Tel: +1 416 Email: support	ad, Units 7 & 8, Markham, Ontario Canada L3R 3W7 416 754-3322 Fax: +1 416-754-3299 pport@edac.net http://www.edac.net ENGINEERING CHANGE NOTICE		
Originator:	Mit Patel		Date:	Document Number	
Phone No.	416-754-3322	2	August 2, 2025	20250802-00	
Email Address:	mpatel@edacgrou	up.net			
Department	Quality		Revision Number	SHEET	
CHANGE TYPE:			1	1 of 3	
CLASS I X CLASS II CLASS III REASON OF CHANGE Tool worn out.	Customer notification and app Customer notification only, no No customer notification requi	approval required	implementation	Group of Companies SINORCOMP SINORCOMP	
DESCRIPTION OF CHAP	IGE:				
dimensional modification	2P001B0E has worn out and has that increases the overall length of elow. Other than this there will be	f the manufactured par	rt, and that will impact the fittin		
	R2		R3		
024 ±005	00,80 ±0.05			Ø0.70

13A-F002 Engineering Change Request (Supplier)

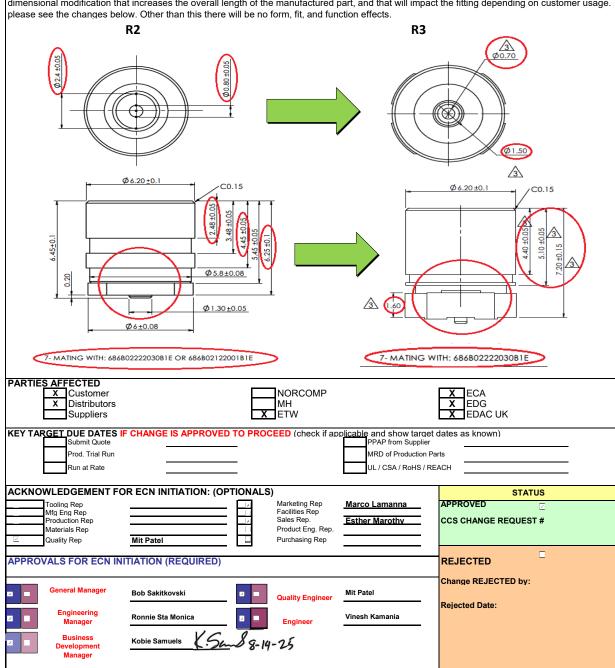
ISSUE NUMBER				
	ORIGINA	AL	1		
1	ADD NO				
,	P.M.	AUG. 9/2023	2		
	DIMENS				
	V.K.	AUG. 08/2025	3
